PLANNING COMMISSION MEETING STAFF REPORT

NAME OF PROJECT: Watts Remund Farms PUD – Phase 4

AGENDA ITEM: Preliminary Phase 4

Subject: Remund Farms – Phase 4 Preliminary Review

WATTS ENTERPRISES
 REMOND FARMS
 PHASE 4
 SITE PLAN

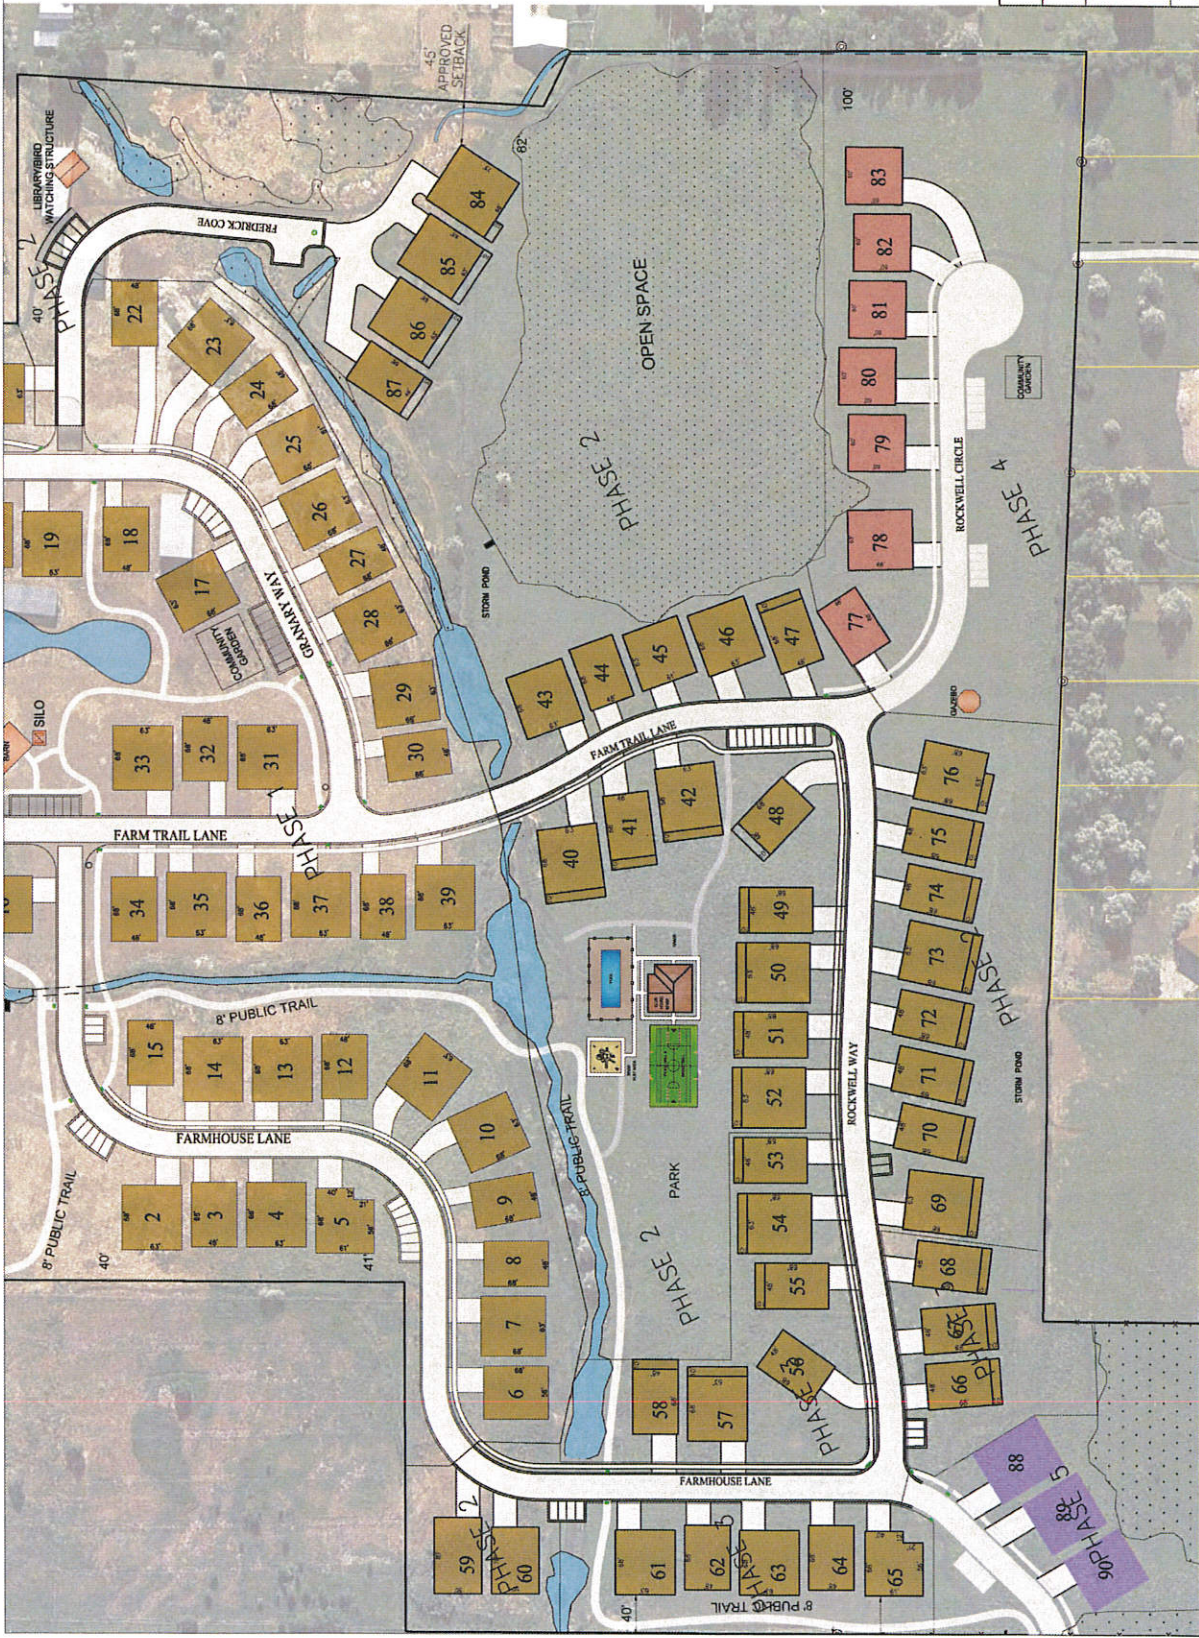
Staggered Setbacks – The Land Use Code requires staggered setbacks to help mitigate the “wall effect” that dwellings with the same setback on a straight street creates. The code states the following in Section 16.16.8.5.c:

Front setbacks for buildings from all private streets within the PUD shall be staggered at seven and one-half feet variances, with 25 feet the minimum setback. One-third of the buildings containing dwelling units shall be at each of at least three different setbacks as recommended by the Planning Commission and approved by the City Council. For example, one-third at 25 feet, one-third at 32 ½ feet and one-third at 40 feet. Setbacks for accessory buildings shall be as recommended by the Planning Commission and approved by the City Council. Setbacks from private streets shall be measured from top-back of curb or back of sidewalk or trail, whichever is further from the street centerline. The City Council may waive this requirement when a curvilinear street design is used and shown to create the same varying setback effect.

The application has staggered the front setback of the units in the proposed phases which will help reduce the “wall effect”.

WATTS ENTERPRISES
 REMUND FARMS
 PHASE 4
 STORM DRAIN PLAN

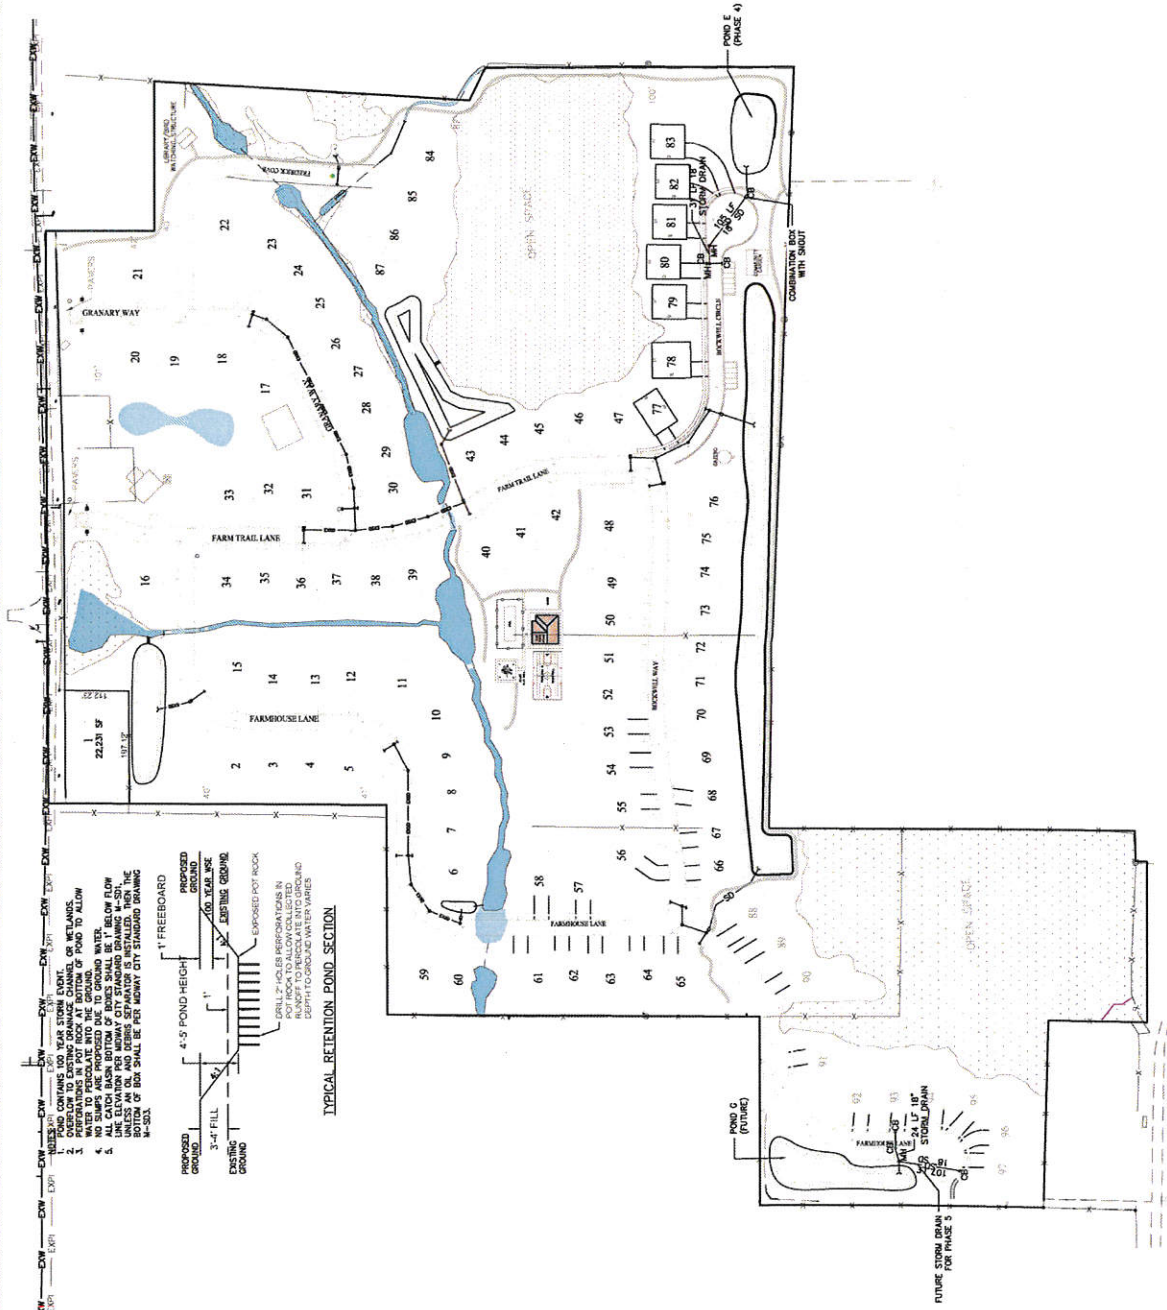
- The storm drain system will be private and will be collected within the proposed curb and gutter and discharged to a series of catch basins and retention basins with the development.
- Remund Farms HOA will be responsible for maintenance of the storm system. This needs to be updated in the development agreement.
